This gallery shows some pictures of bad solderings - they should prevent you from making the same errors (feel free to add even more pictures here!)

From:  
<https://www.midibox.org/dokuwiki/> - **MIDibox**

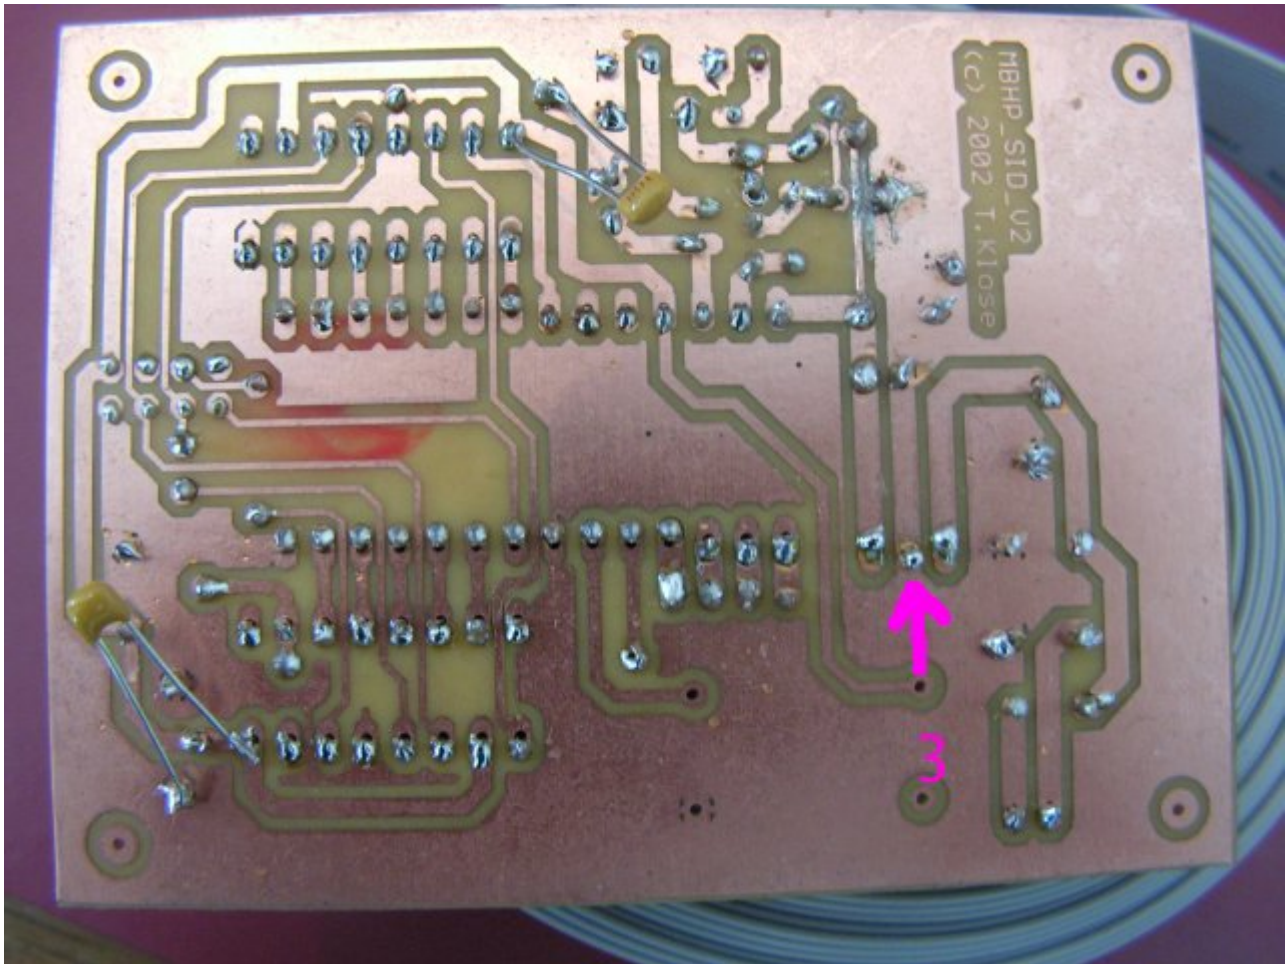
1: the core module has some bad solderings (loose connections), which could lead to failures. There are also missing solderings (e.g. 33pF cap below crystal). It makes sense to solder each pad again, the [Soldering](#) guide in the Wiki gives some useful tips

2: the legs of the caps should be cutted, otherwise they can cause a short circuit which can damage the PIC!

3: this seems to be a bad ground connection directly at the 78xx - it can lead to the wrong voltage. Here the same: just solder the pads again, it will help

And same like above: the long cap legs need to be cutted, the danger for shorts is too high!
